February 13, 2007

## **TEAM UPDATE #11**

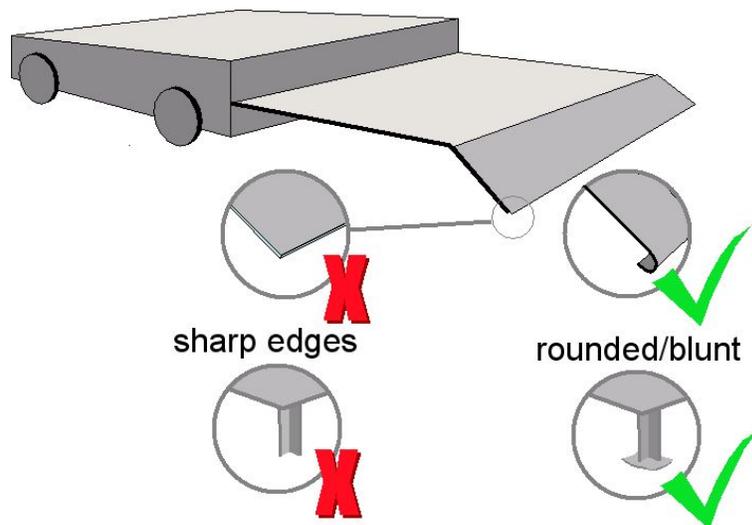
3. As teams prepare the Bill of Materials that must be presented at Inspection, we would like to invite them to use the template posted under *Section 8 – The Robot* on the *FIRST* website.
4. A reminder to teams using the SMC pneumatic solenoid valves - The valves were shipped with 24V coils installed on them. For competition, it is imperative that teams remove the 24V coils and replace them with the 12V coils provided in the SMC pneumatics bag.

The process involves the following steps:

- remove the two screws that secure the 24V coil to the valve
- discard the 24V coil, but save the screws
- align the 12V coil to the valve in the same way the 24V coil was

- aligned (with the marking “12VDC” next to the orange reset button)
- use the screws to secure the 12V coil to the valve
